# Device Errata for the MPC850 Family

This document is a compilation of all MPC850 family device errata from silicon Revision 0.0 forward. Herein, the errata are classified and numbered, and each erratum is provided with a description and workarounds.

**G4 Potential problems caused by skew between EXTCLK and CLKOUT**

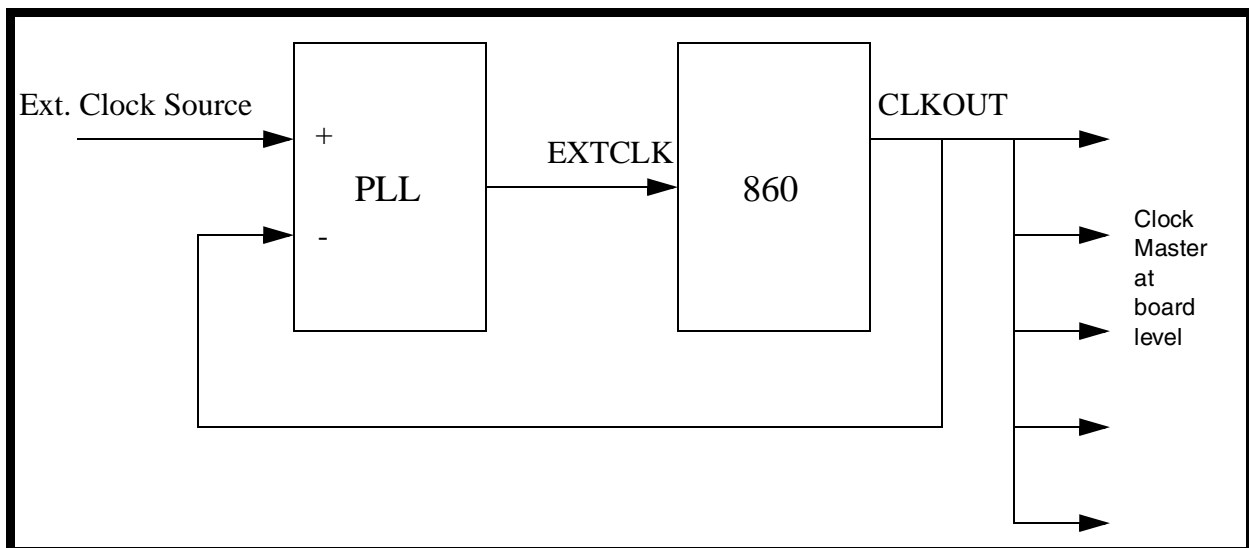
In correct operation, the PLL of the MPC850 will lock on the rising edge of the input clock. However, on these revisions of the MPC850, the PLL may lock on the falling edge of the input clock. This will affect the skew between EXTCLK and CLKOUT at the rising edge. The skew is dependent on the duty cycle of the input clock (but for a 50% duty cycle will not exceed 2nS). This will affect synchronous designs where the same clock source is used as an input to EXTCLK, as well as to an external synchronous device (for example, a peripheral or ASIC).

Case 2. Where it is necessary to synchronize an external master clock (for example, from a backbone), an MPC850, and external peripherals, to allow data transfers in all three directions:

[NOTE: This workaround is a concept only. It has not been verified in hardware.]

Insert a PLL between the external master clock and the EXTCLK pin of the MPC850. Connect the phase comparison pin of the PLL to the CLKOUT pin of the MPC 860. Also use the CLKOUT signal as the reference clock for distribution to the local external peripherals.

Important Note: The PLL has to be capable of operating with a permanent offset of -2nS, therefore the range of lock should extend to about -4nS.

A diagram of this concept is given below:
